Documents for presentation to the Legislative Assembly under
section 79 of the *Planning and Development Act 2007*

Variation to the Territory Plan 344

Woden Town Centre:
Zone changes and amendments to the
Phillip precinct map and code

August 2018

Figure 3: Areas subject to rezoning

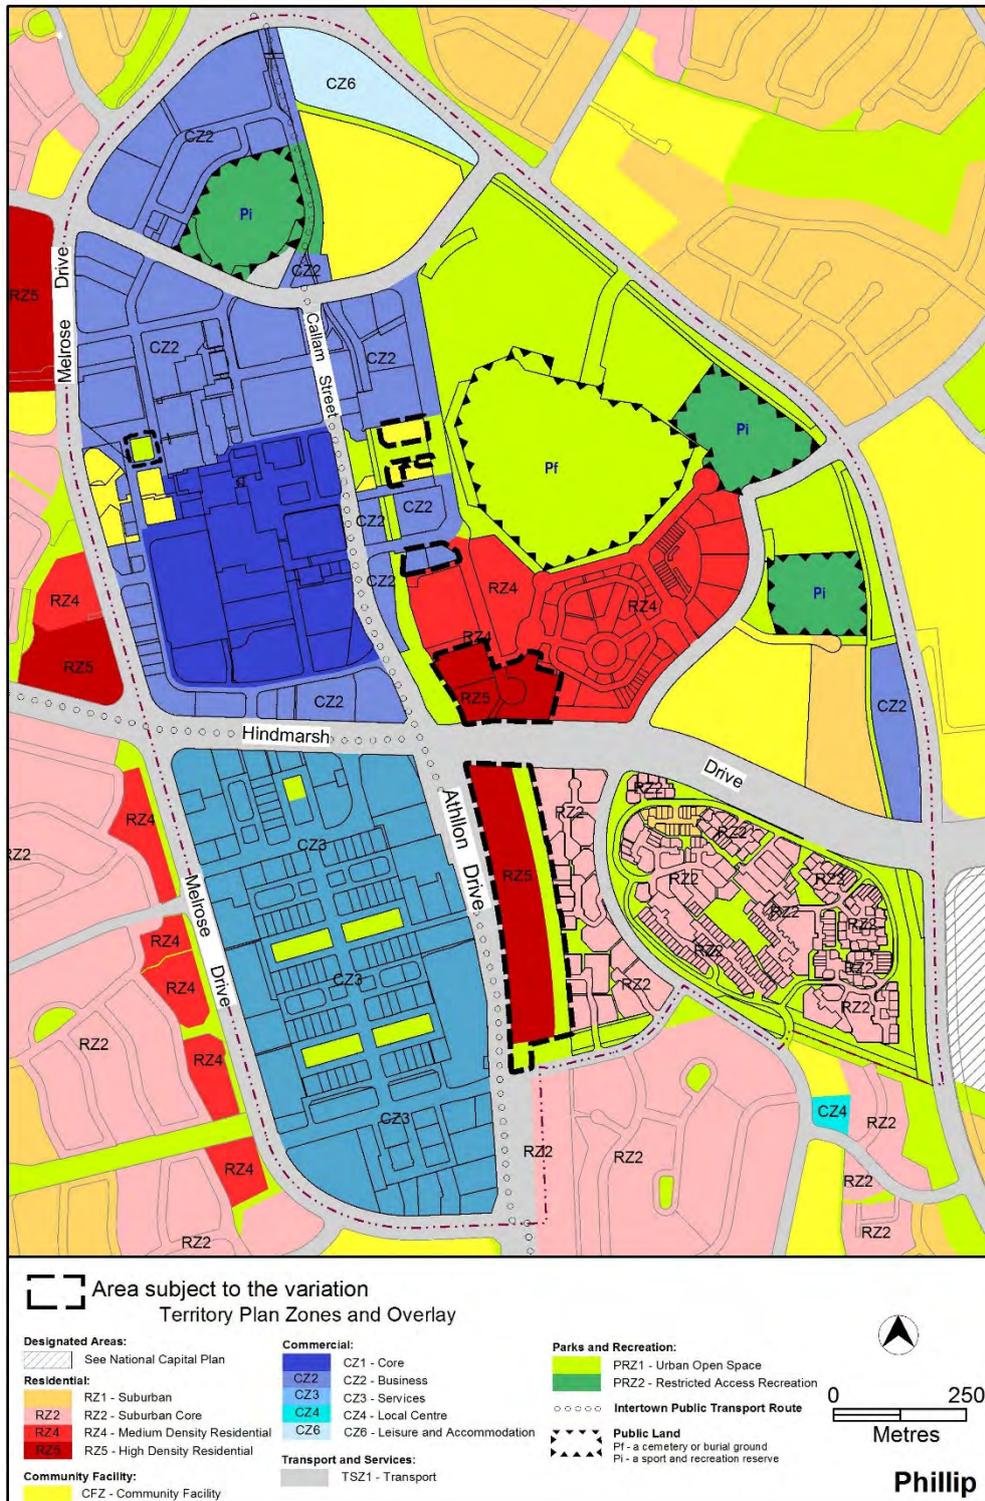
- rezoning block 1 section 181 from CZ2 to PRZ1 urban open space
- removing block 1 section 181 from area b in figure 2 of the proposed precinct code as it will be public open space,

- increasing the area permitted for supermarket for block 13 section 81 from 500m² to 800m²
- amending criterion C11 and associated figure 2 to clarify that the marker building may be permitted anywhere within the block, and not necessarily restricted to the north west corner at the Melrose Drive and Launceston Street intersection

Figure 2 Building heights and marker buildings

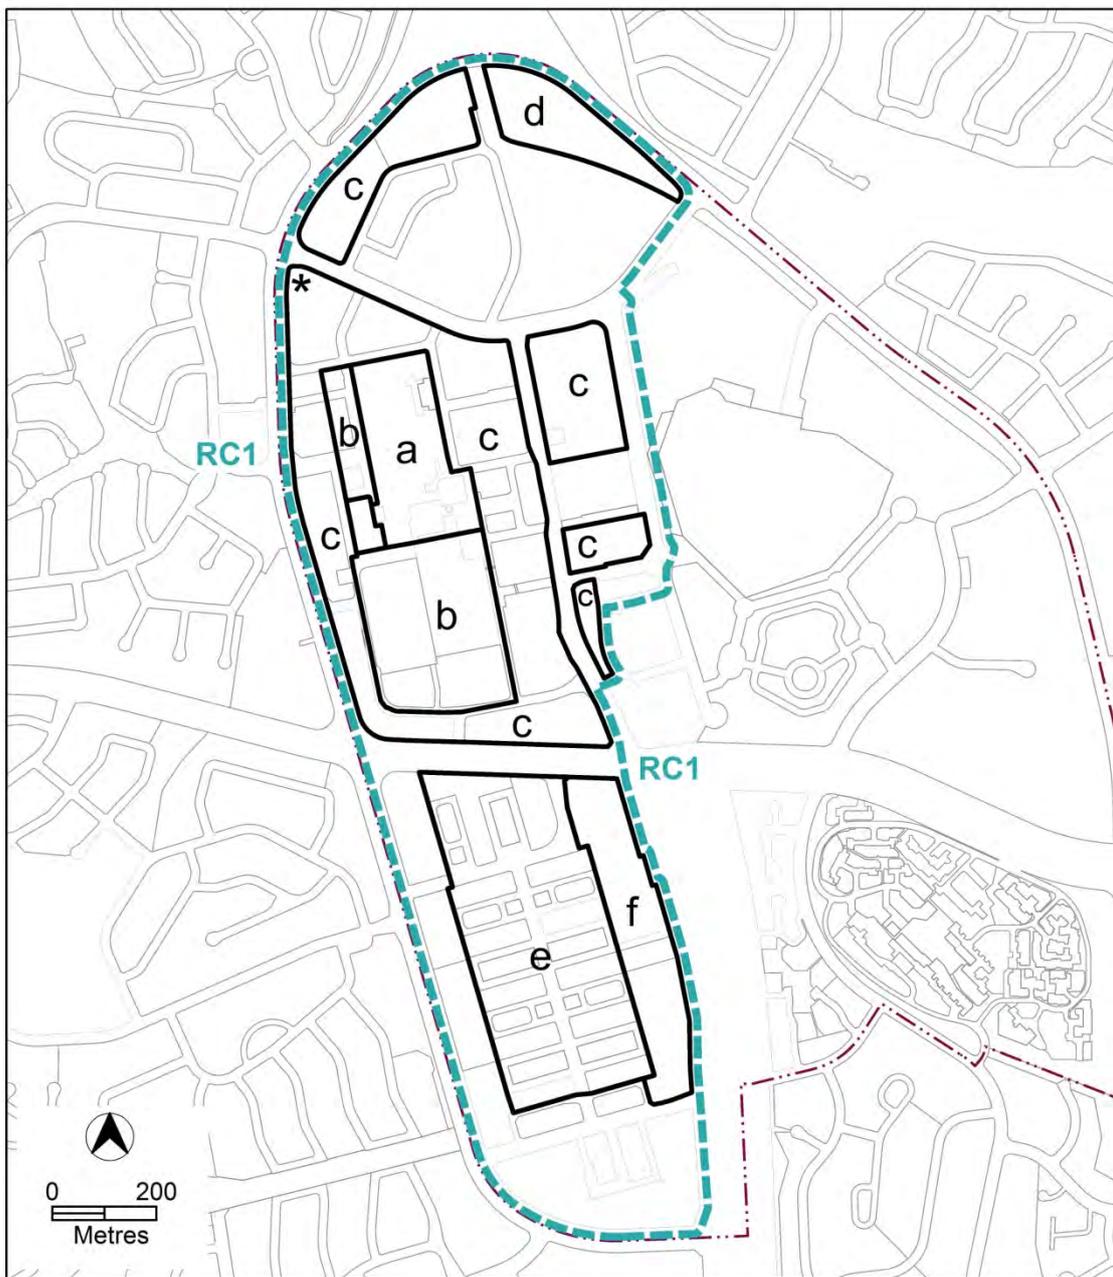
The cadastral base used for key figures in the Draft Variation document is lacking in detail, making identification of applicable building heights (Figure 2) difficult, particularly where block/section identifiers are not present. This is particularly so for Block 20 Section 8 Phillip which is not always shown as a separate block. Figure 2 is a critical figure for the identification of applicable building heights – yet it is poorly resolved in its underlying detail. For clarity, and indeed certainty, it is suggested that Figures 1 and 2 of attachment B (Phillip Precinct Code) should be re-drawn on a detailed cadastral base showing street names, blocks and sections.

Figure 3

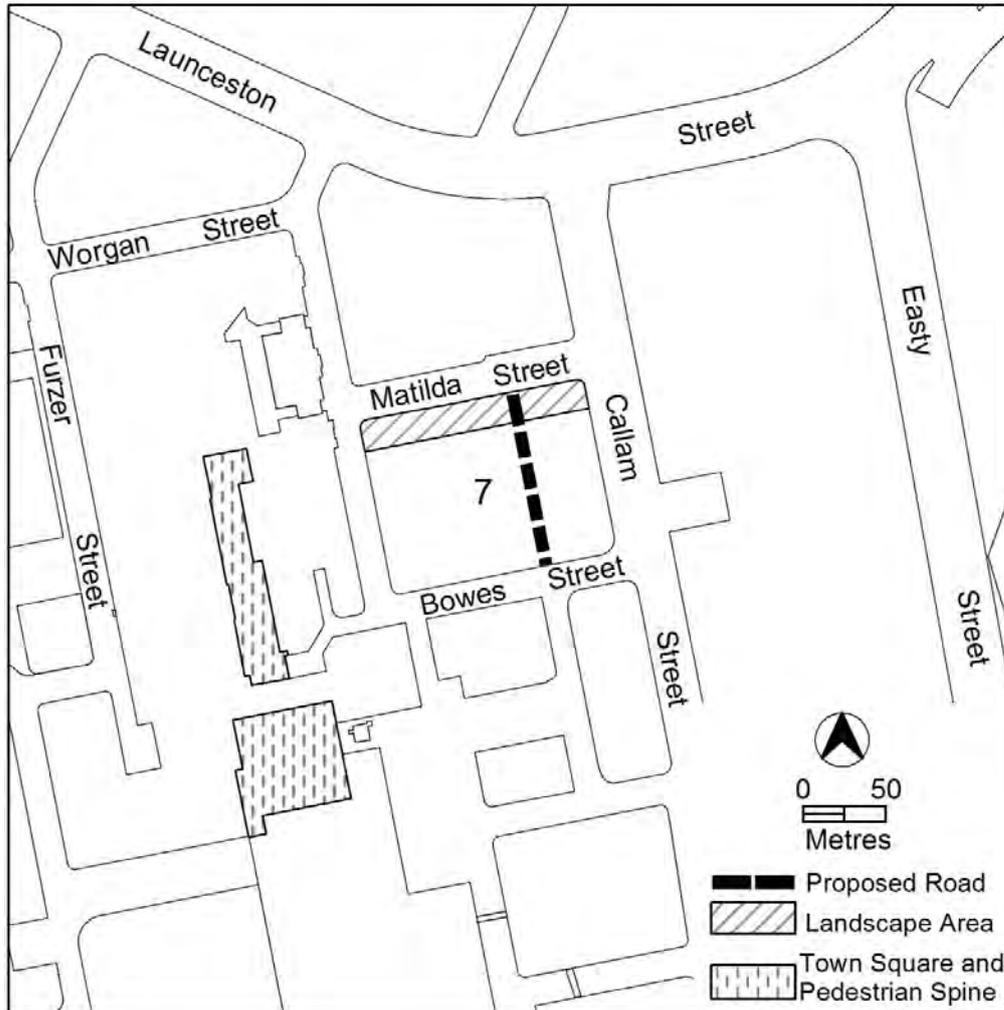
5. Criteria 10(a). Small typo – change “an” to “and” on first line, or else add a comma before “an” on first line.
6. C16(b), R18(a), R22(a) & (b). The reference should be to Figure 3, not 4.

Rule 33 the references to the town square and pedestrian spine should also say 'shown in figure 3'. Note also that figure 3, not 4, should be referenced in Criteria C16, and Rules R18(a) and R22(a) and (b). Rule 33 should be reworded to clarify the awnings are required along the entire length of the building as follows:

Figure 2 Building heights and marker buildings

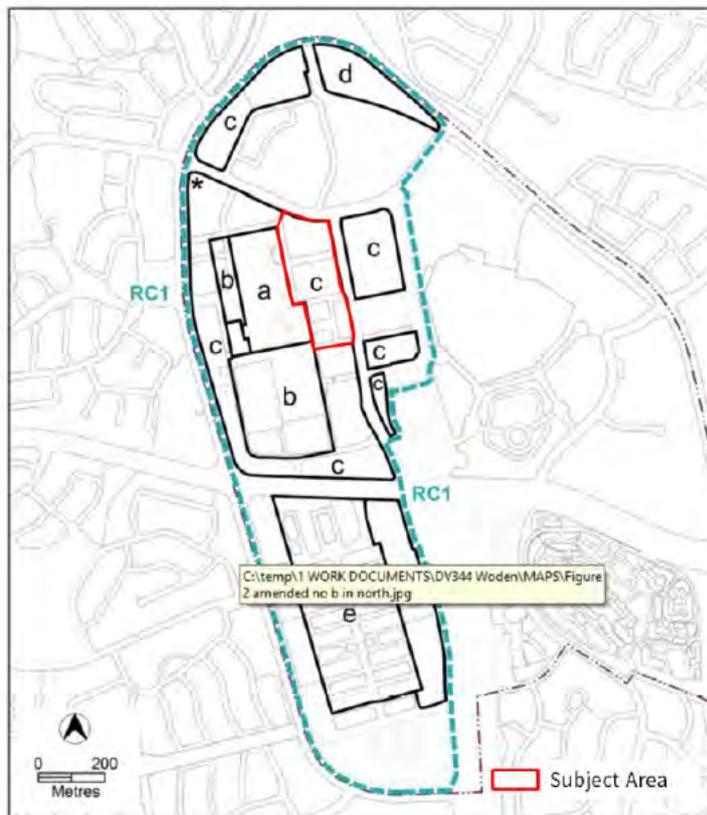
To fulfil the centre's potential, the northern part of area 'c' between Launceston Street and Bradley Street, in line with Lovett Tower, should be rezoned to area 'a' (see red section in Figure 1 below). This would not only allow for a larger centre promoting greater activity and vibrancy, but will also help to integrate the Woden Bus Interchange into the Town Centre and herewith encourage and enable increased public transport usage and active travel modes. Woden also stands to potentially gain the benefit of light rail in years to come. The viability of the Town Centre, and the development density required to support that public transit network, will be critical to the overall success of the significant investment made by the ACT Government. This current planning process is a crucial opportunity to do so. Appropriate rezoning would also provide a more balanced appearance of the centre, with a clear built form transition on both sides of the Town Centre from 16 to 24 storeys.

Amendments to building height limitations within the area indicated would also make development within the Town Centre more viable for developers. If strict height limitations are placed on sites, developers will be inclined to build more bulky developments to achieve sufficient yields. Rather, more slender, taller developments should be encouraged, as these would enhance the centre’s built form. In order to manage such development challenges, the development rules regarding building heights (such as R41) should be accompanied by criteria, to ensure that there is appropriate dialogue between government agencies and developers to ensure innovative, appropriate developments are added to the Town Centre. This criteria could be framed with high quality, contemporary designed buildings which will contribute and not detract from the town centre aligning with priority A and C of the *Statement of Planning Intent*.
